PORTION OF SE QUARTER OF SEC 27, TWN 20 N, RGE. 4 E, W.M.
CITY OF PUYALLUP, PIERCE COUNTY, WASHINGTON

No.	Date	By	Ckd.	Appr.	Revision
1	12/06/23	DL	DL	JSG	RESPONSE TO CITY COMMENTS, DATED 10-06-2023

Title: COVER SHEET
CIVIL PLANS
FORTRESS - PUYALLUP

CIVIL TESC AND DEMOLITION PLAN

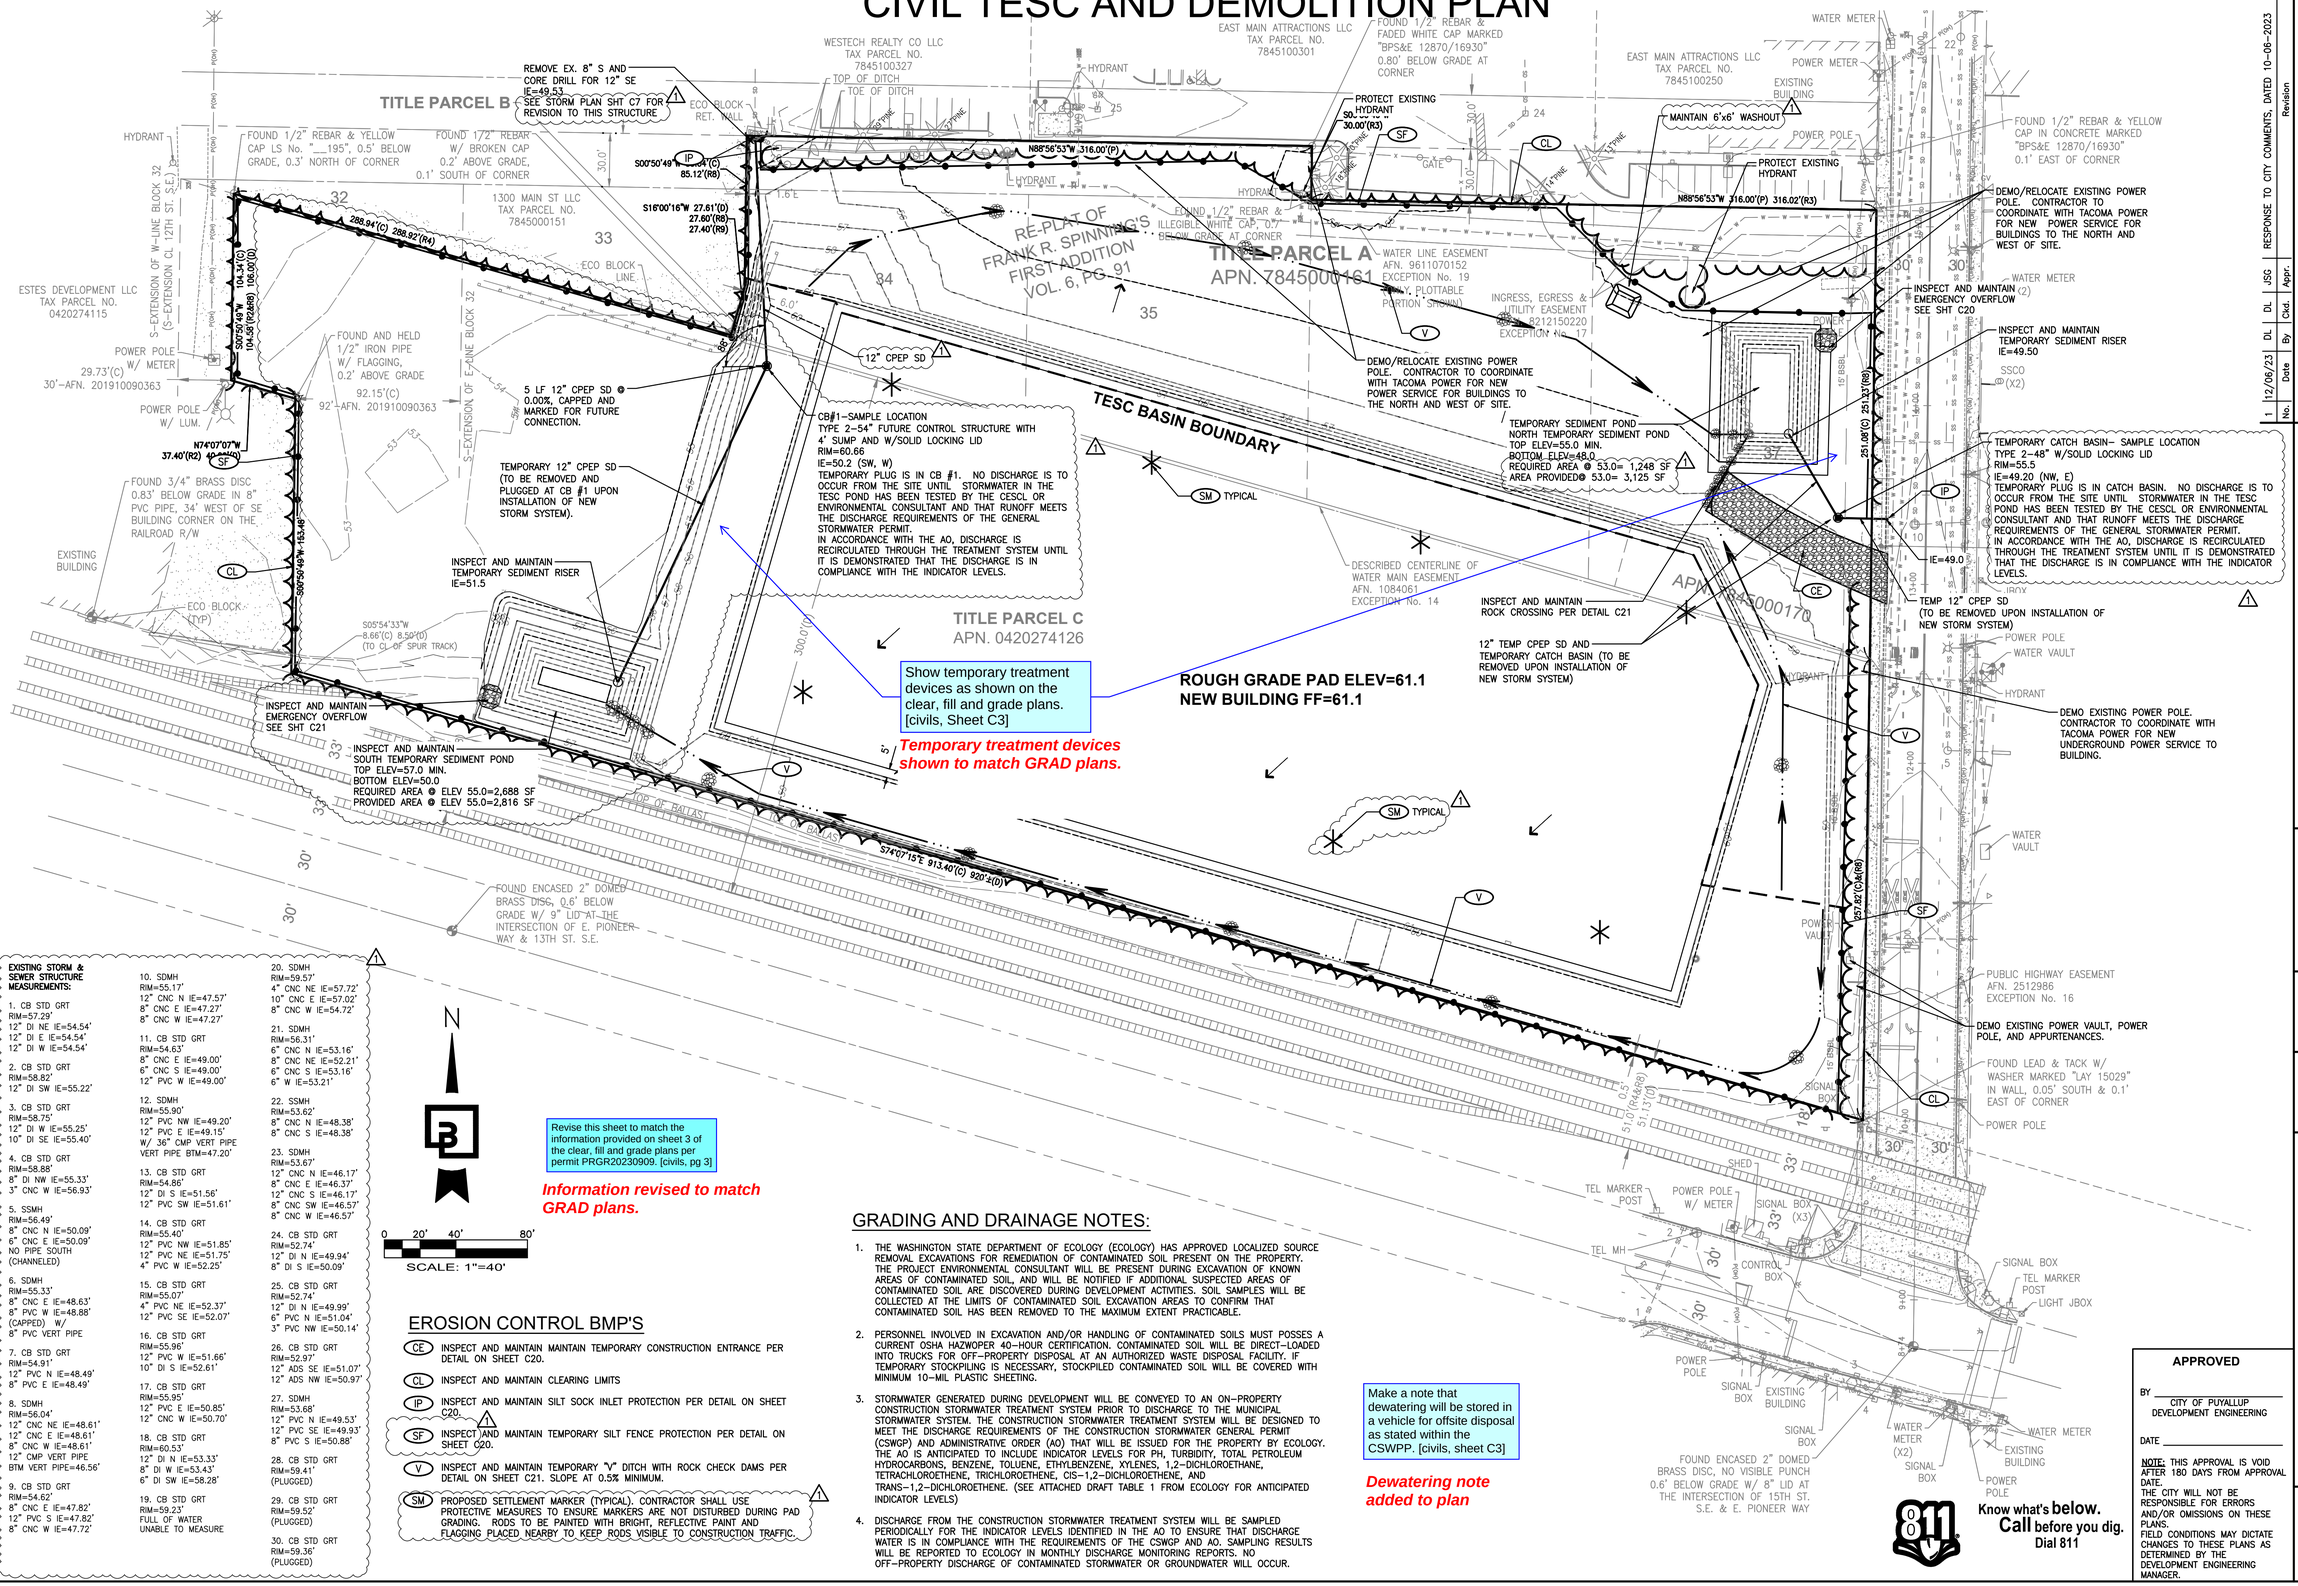
Revise this sheet to match the information provided on sheet 3 of the clear, fill and grade plans per permit PRGR20230909. [civils, pg 3]

Make a note that dewatering will be stored in a vehicle for offsite disposal as stated within the CSWPP. [civils, sheet C3]

Job Number 22085
Sheet C7 of 32

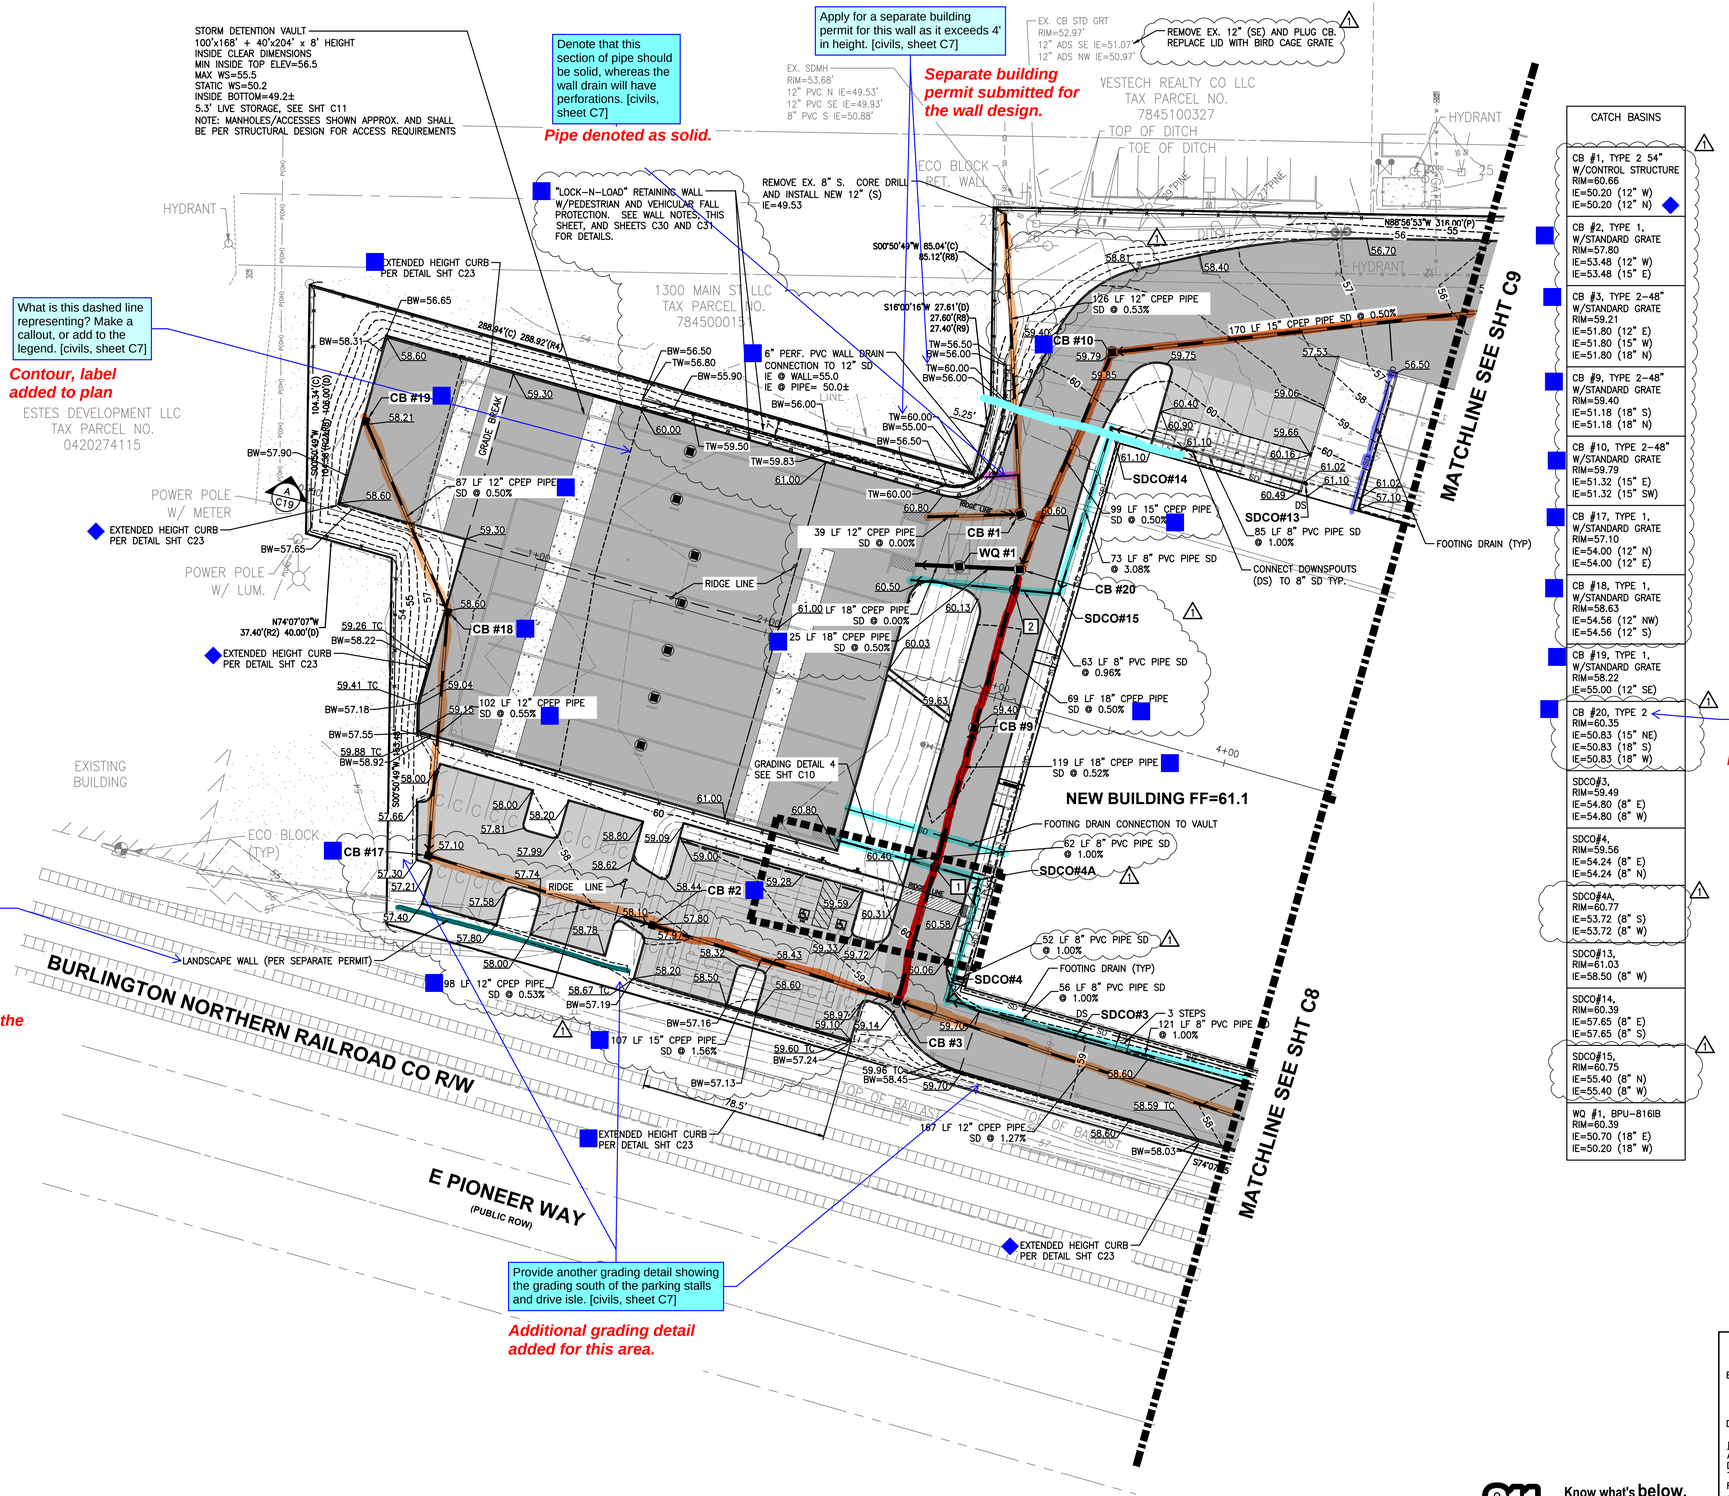
Indicate if this will be a solid or standard grate lid. [civils, sheet C7]
Lid type added to plan.

Sheet C9 of 32

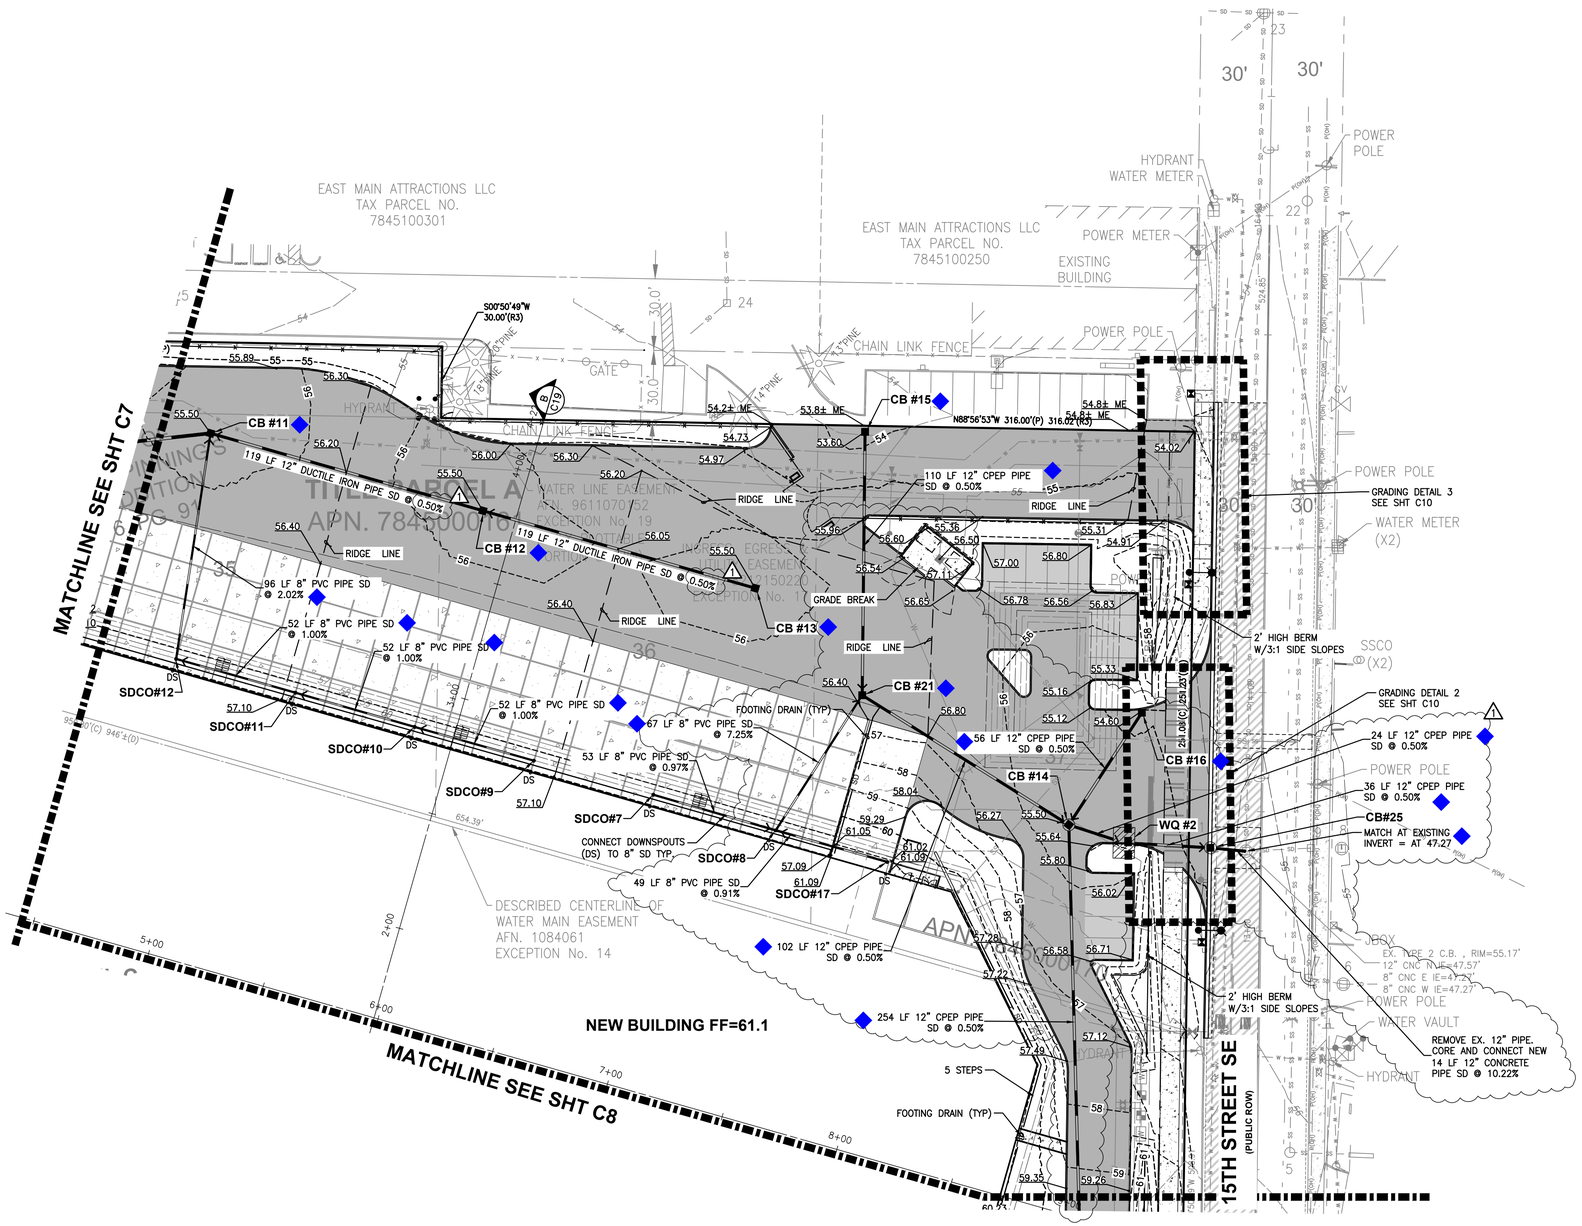
The elevation between the rim and IE is greater than 5', revise to a type 2 catch basin. [civils, sheet C9]

VAULT DETAIL 1

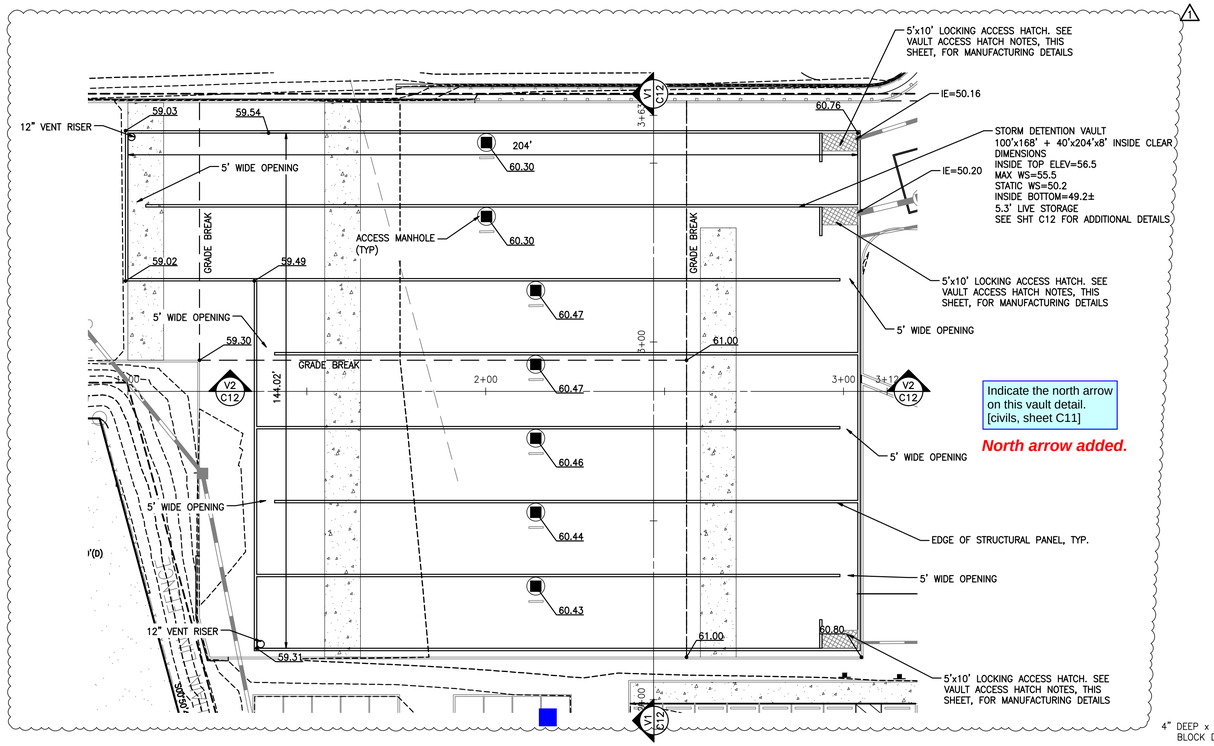
Indicate the north arrow on this vault detail. [civils, sheet C11]
